ADDENDUM NO. 1

TO: All Holders of Plans and Contract Documents for Moniteau County, BRO-R068(05) Pilot Grove Road Bridge No. 1550021 Replacement Over Trib of N Moreau Creek

ISSUED: March 16, 2026

**DETAILS OF INTEGRATED APPROACH**  
PILOT GROVE BRIDGE REPLACEMENT  
BRO-R068015 BRIDGE # 1550021  
S 14 T 44N R 16W  
MONITEAU COUNTY MISSOURI

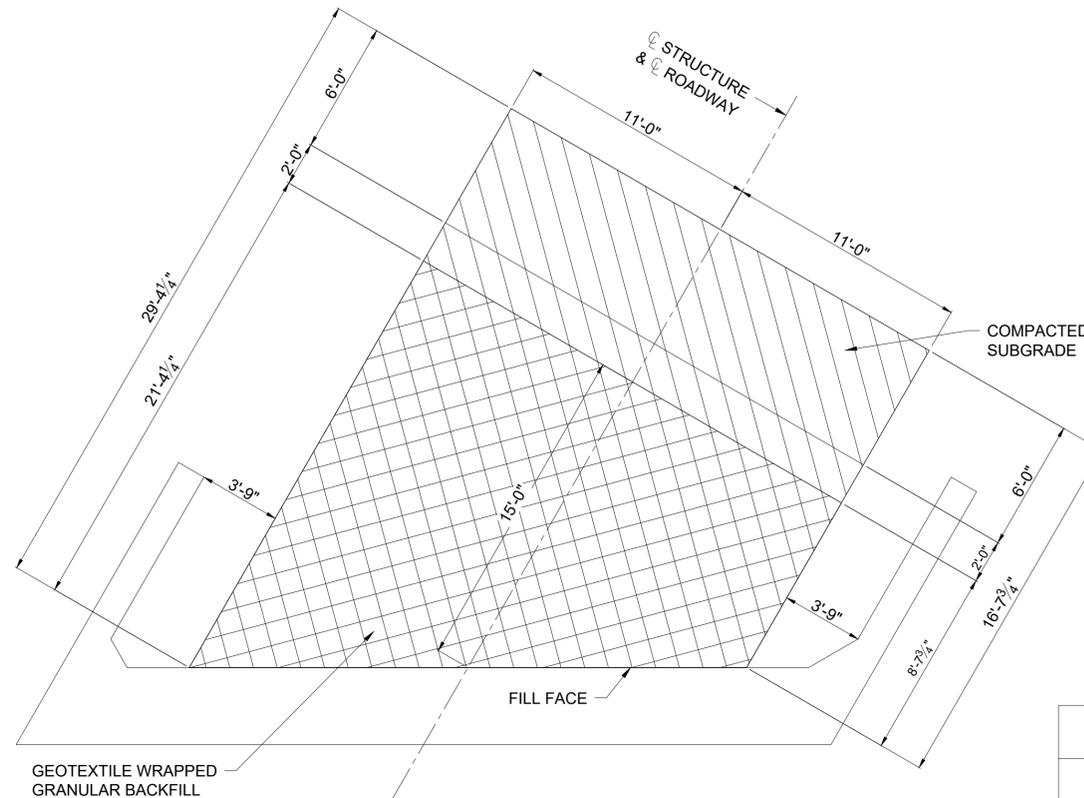
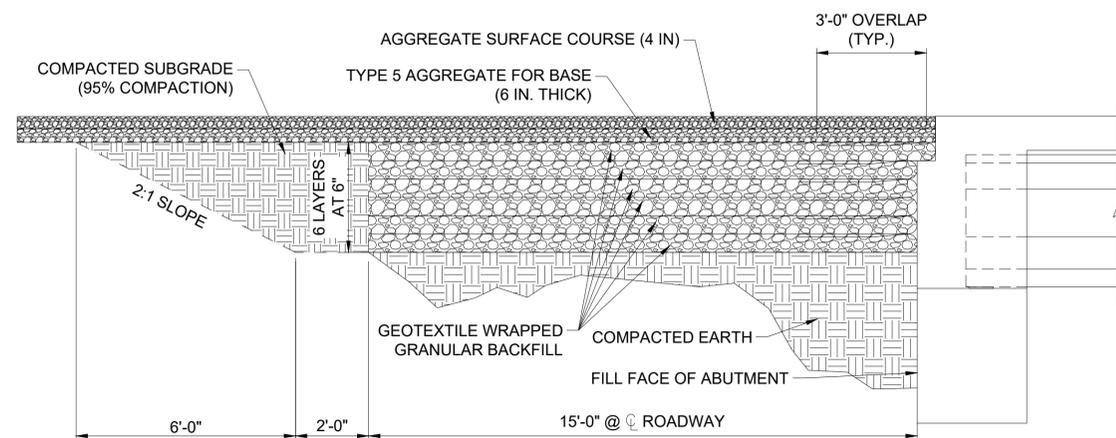
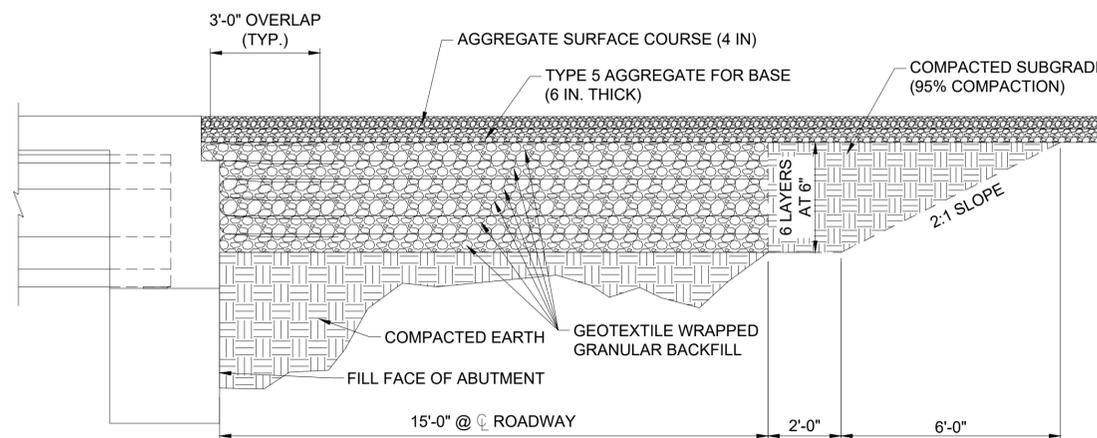
- Sheet 02A
  - Addition of Sheet 02A
    - Sheet 02A provides details and estimated quantities in relation to Itemized Proposal "No. 7, 304-99.05, Integrated Approach, S.Y., 98.0"
